Project
BURWOOD PLACE
42-60 RAILWAY PARADE, BURWOOD NSW

Drawing Title
TOWER B - LEVELS 18-20

Project Status
DEVELOPMENT APPLICATION (S4.55)

AR-DA-2310

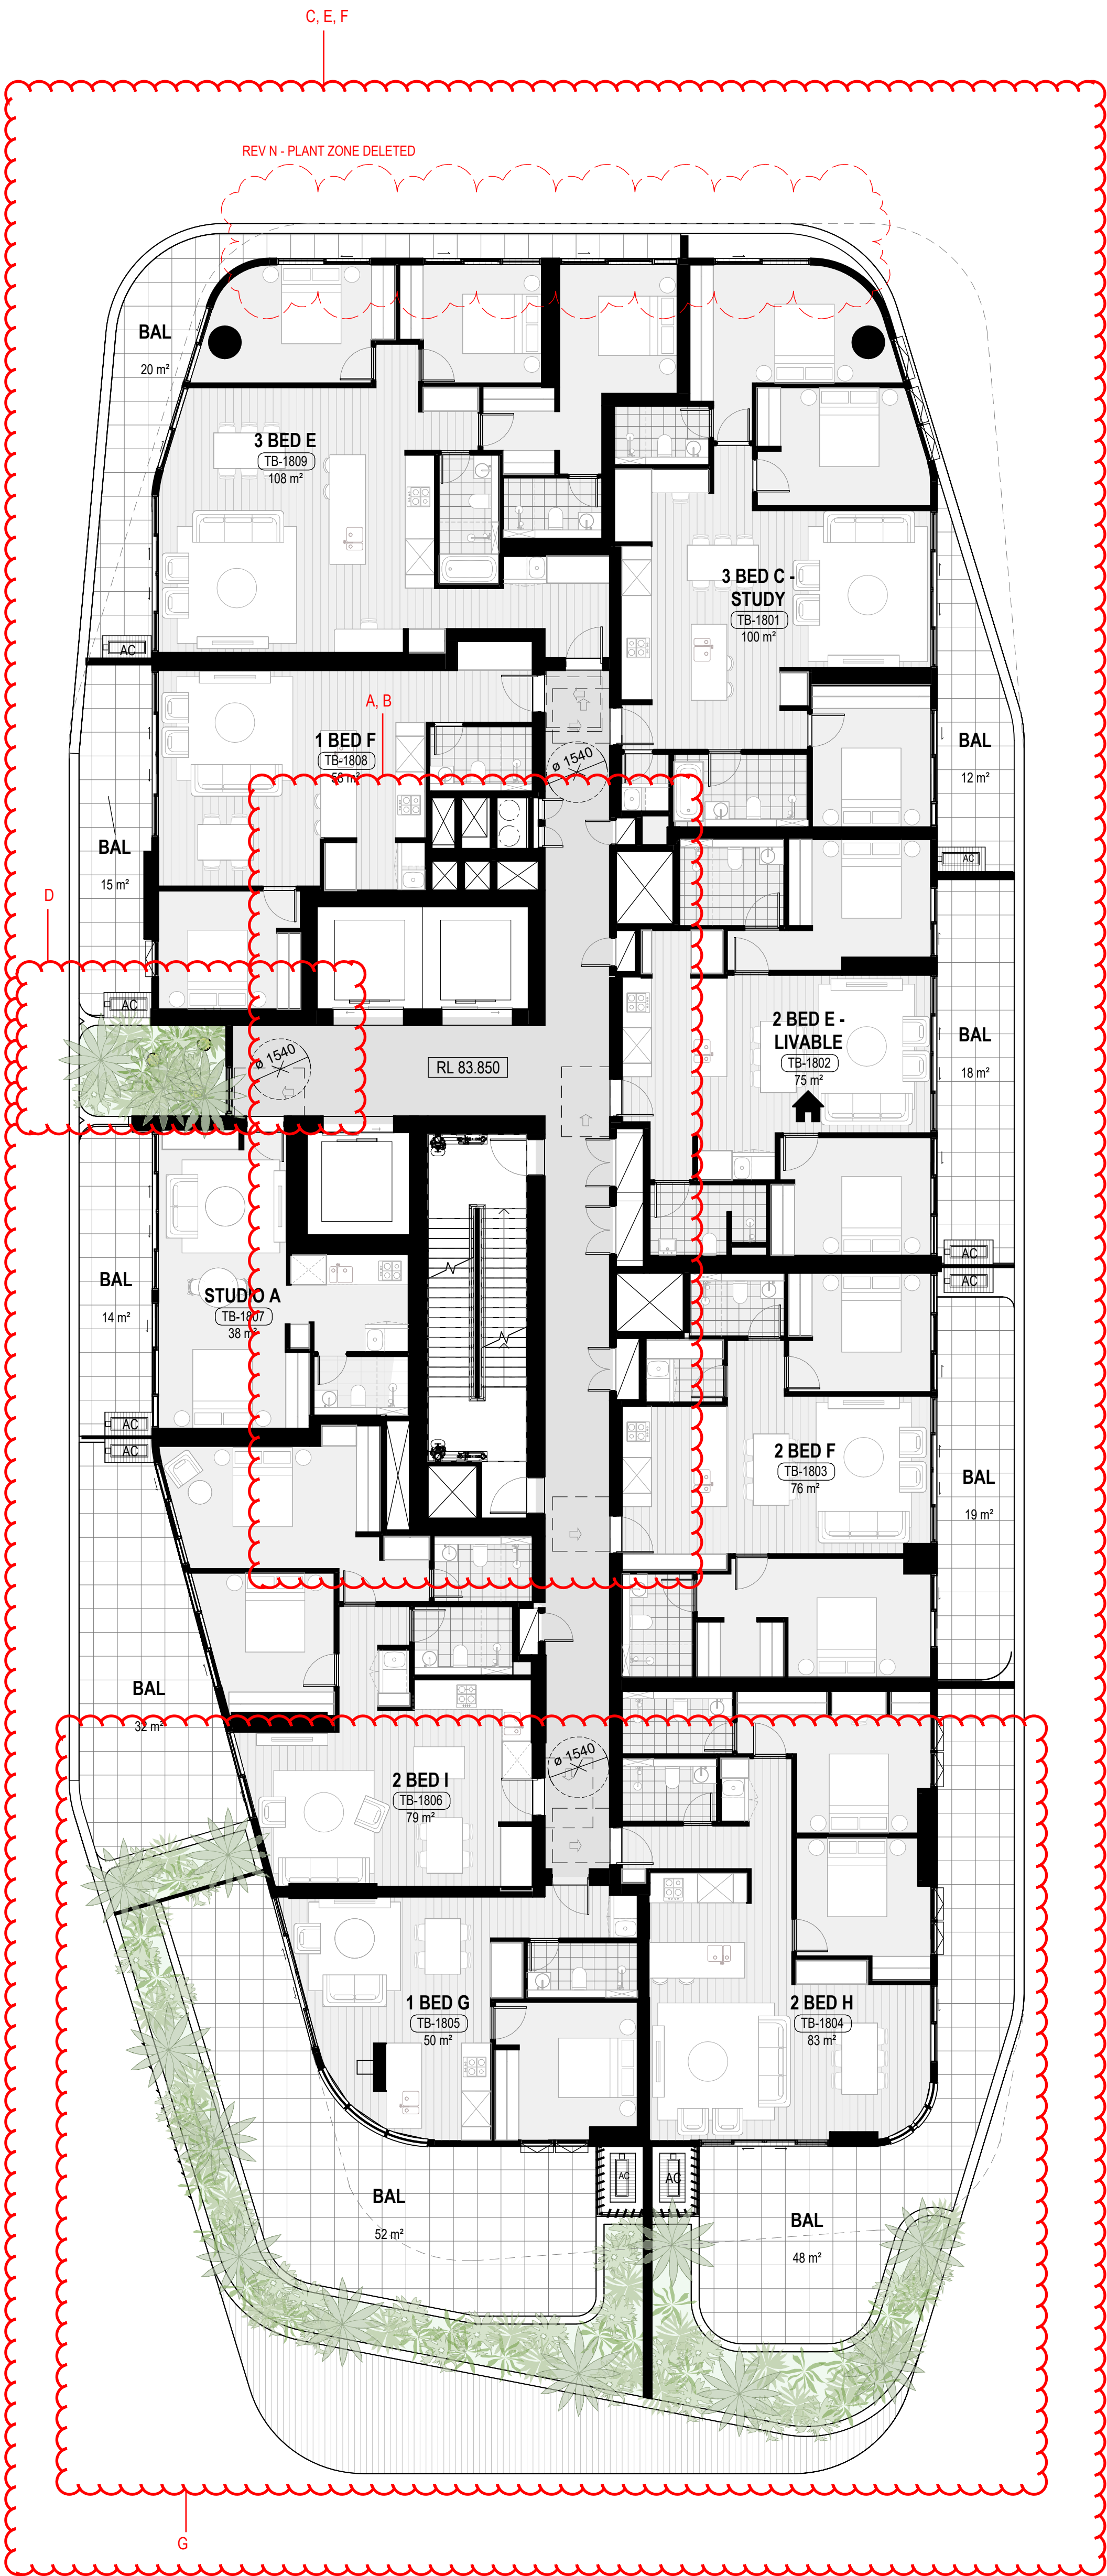
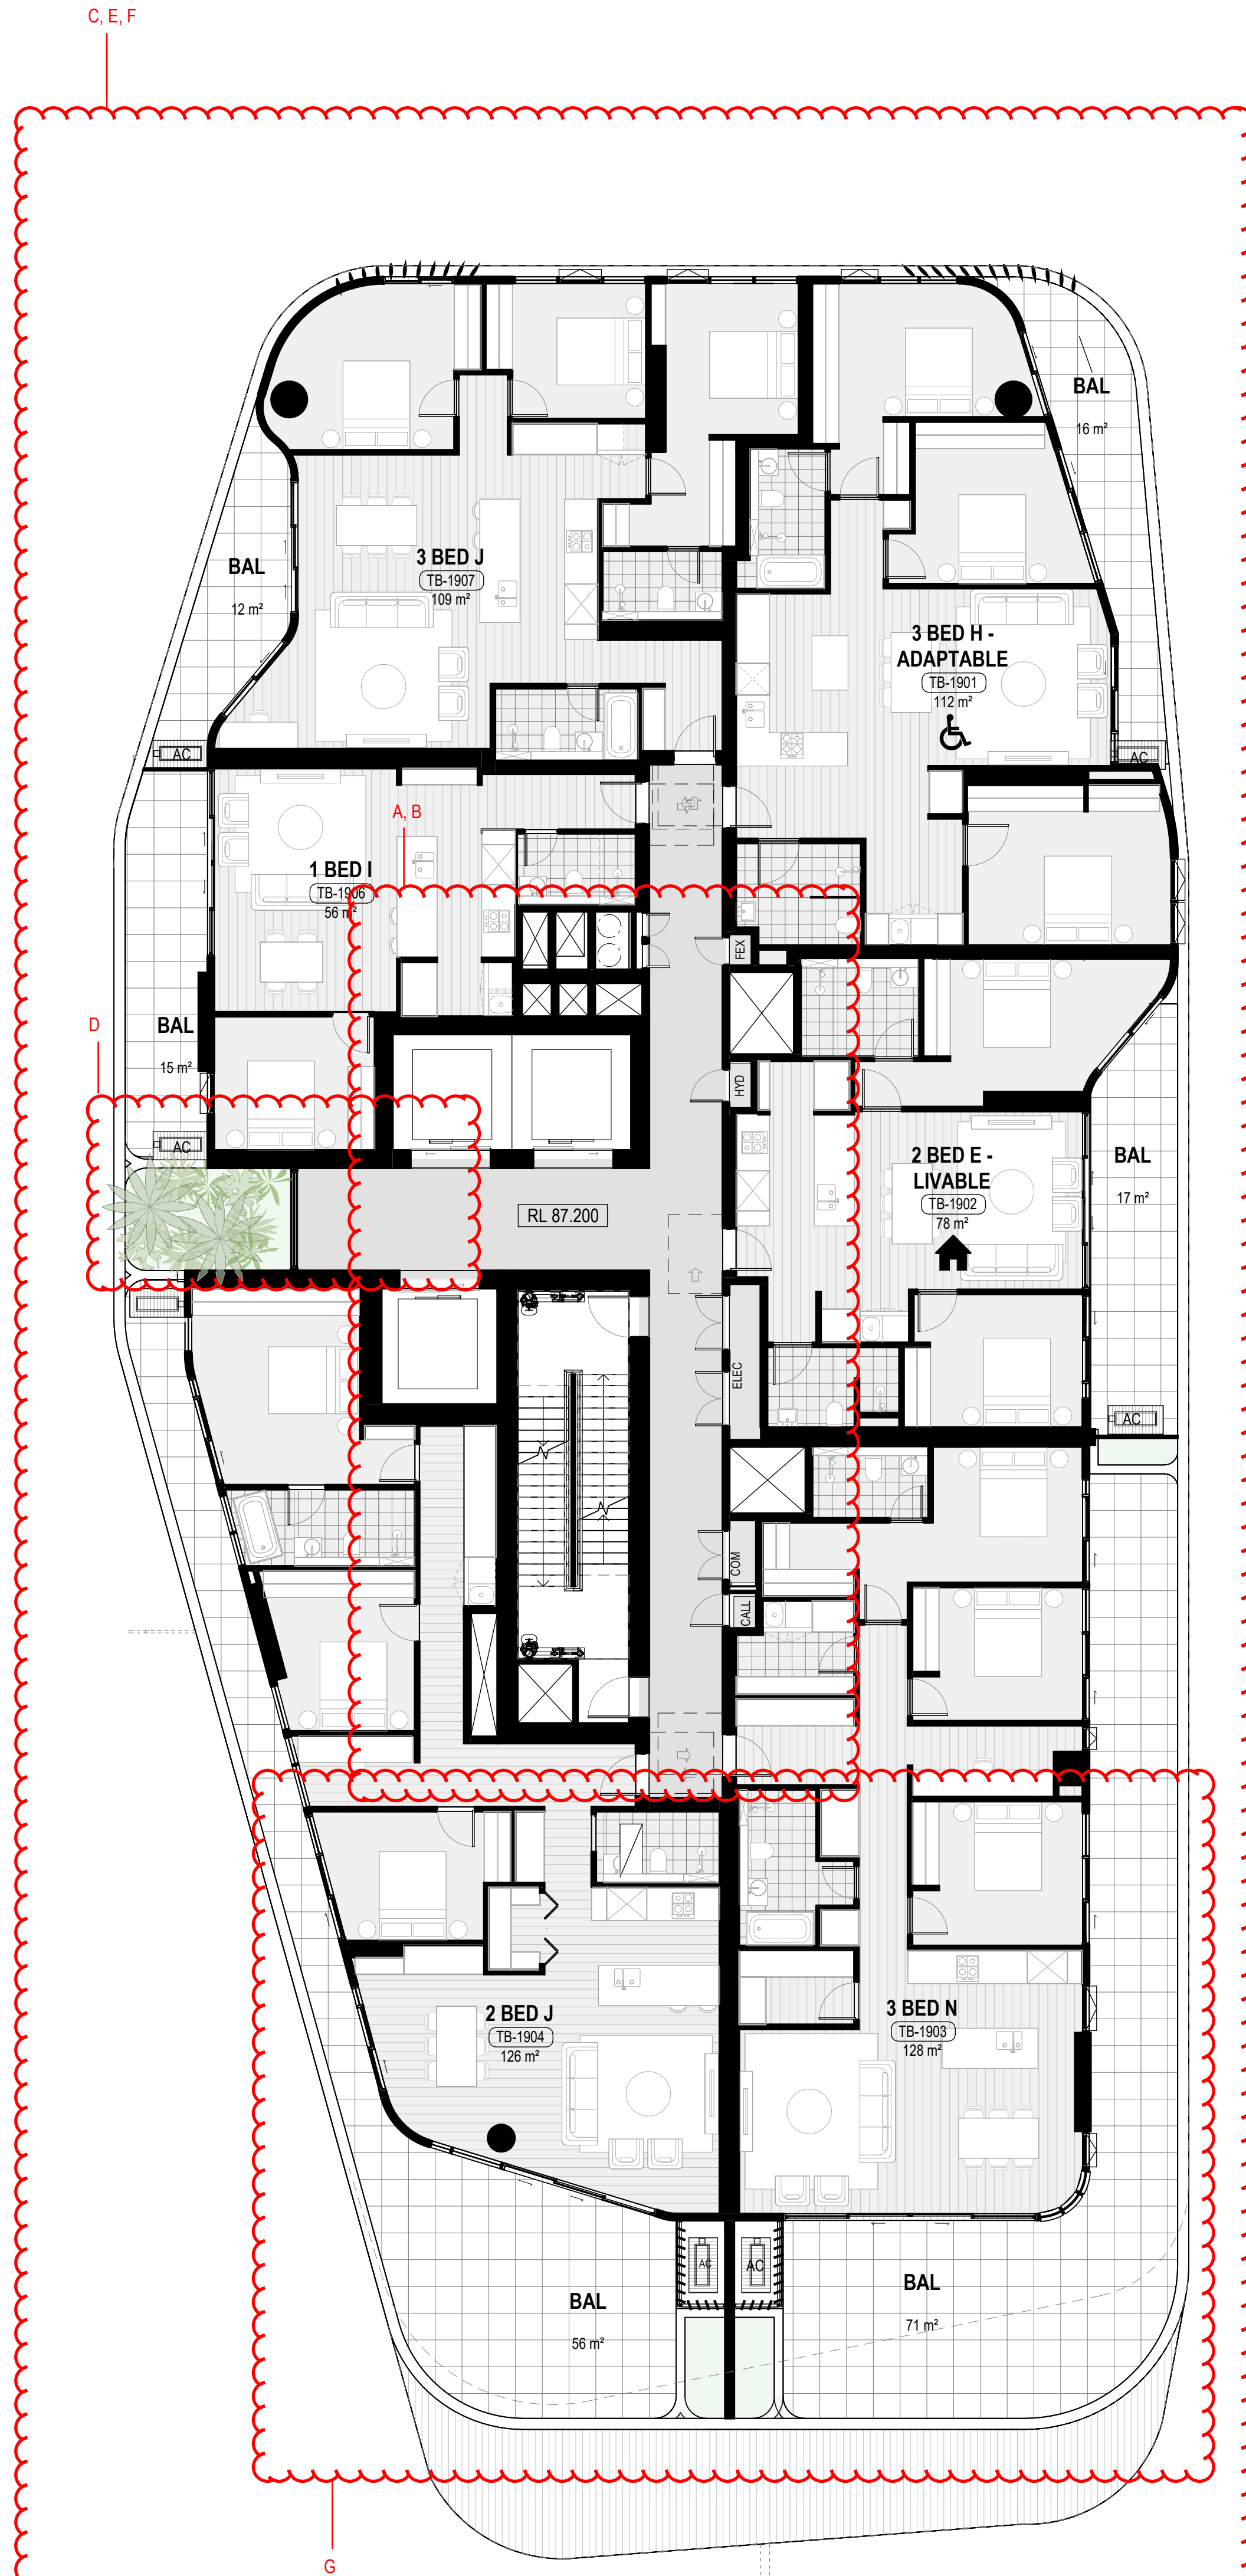
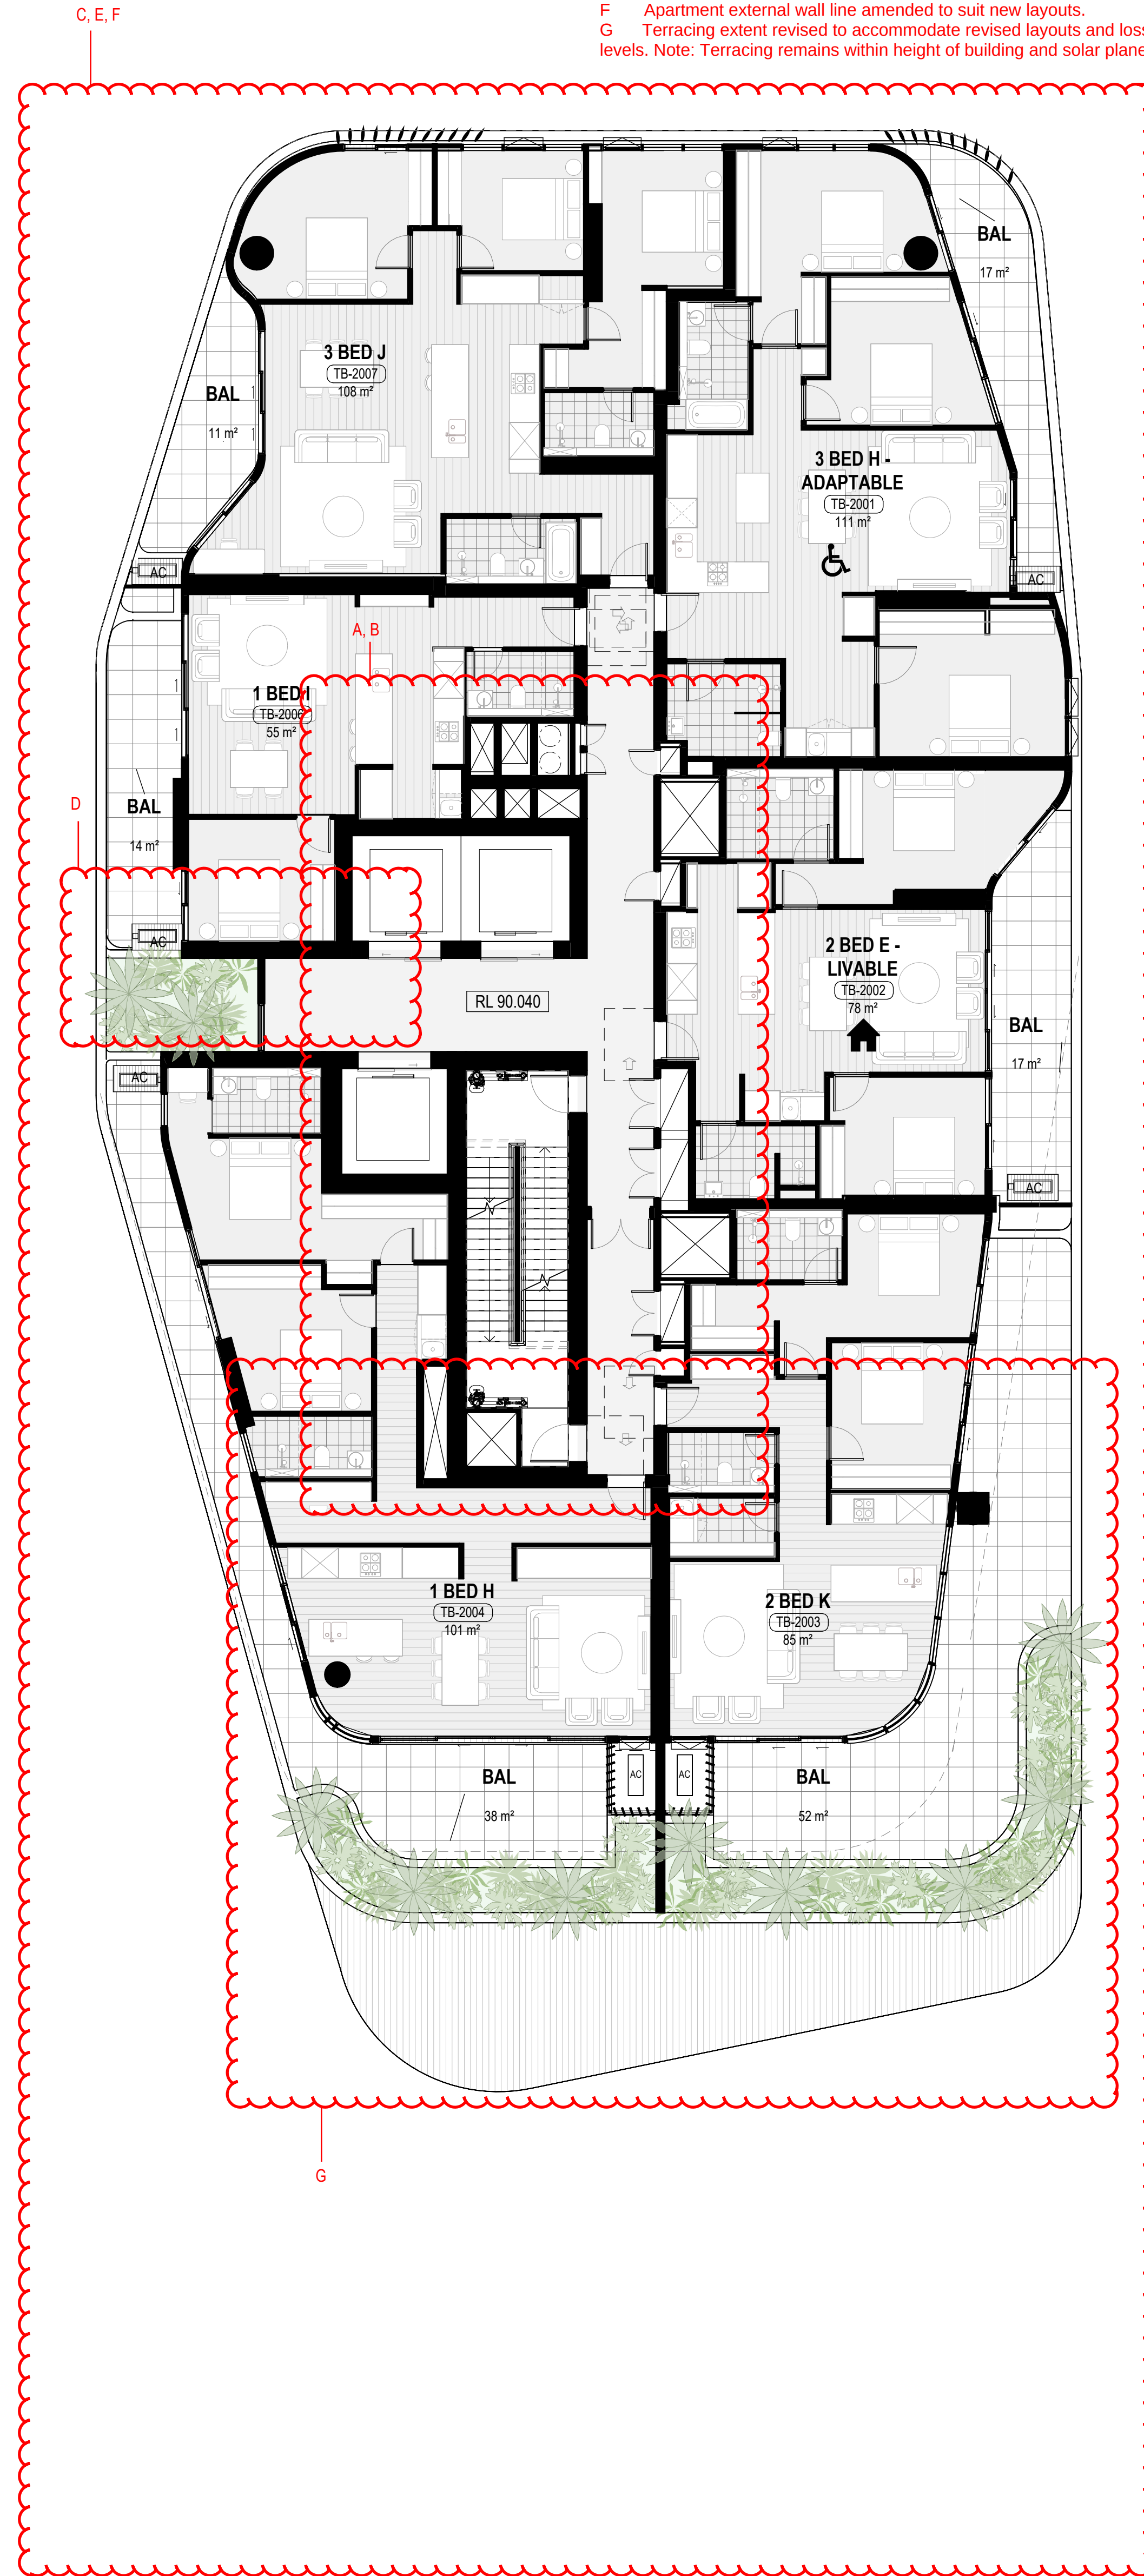
- A Stair and core locations shifted.
B Services revised based on design development requirements.
C Apartment layouts revised to respond to:
o Services and structural changes
o Improve amenity and relationship to façade and balcony placement.
o Reduce long dog leg corridors.
o Introduction of island benches to kitchens where possible for improved amenity
o Bath to 3-bedroom apartments
D Condenser plant rooms added to residential floor levels.
E Apartments redistributed across the plate.
F Apartment external wall line amended to suit new layouts.
G Terracing extent revised to accommodate revised layouts and loss of area through lower levels. Note: Terracing remains within height of building and solar plane limits.
